PERMIT

SEWAGE DISPOSAL SYSTEM
HOWARD COUNTY HEALTH DEPARTMENT
BUREAU OF ENVIRONMENTAL HEALTH
410-313-2640

SUBDIVISION Brantwood 2/1 LOT NUMBER 7 ADDRESS 11429 Butterfruit Way

515024-B

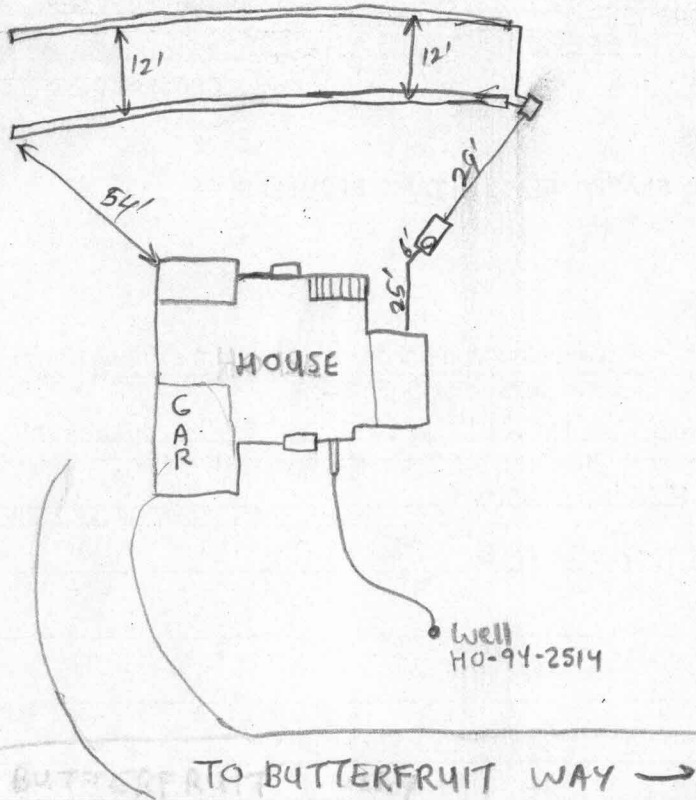
RUN 2' - 120' TRENCHES TOWARDS LEFT LOT LINE (SRW)

PRE-CONSTRUCTION INSPECTION: 4/18/01 - EASEMENT NOT STAKED - JOB SHUT DOWN - SRM
4/20/01 SOA staked - layout confirmed - OK to begin installation
 INSPECTION COMMENTS: 4/30/01 - RUN 2 - 120' TRENCHES INSTEAD OF 3 - 80' TRENCHES - SRM
Needs House Connection, Septic Tank OK, "T" Baffles OK, Dist Box and both drainfield trenches OK to cover. RPP in place 5/2/01
6/20/01 House connection verified - FINAL INSP OK. DKC
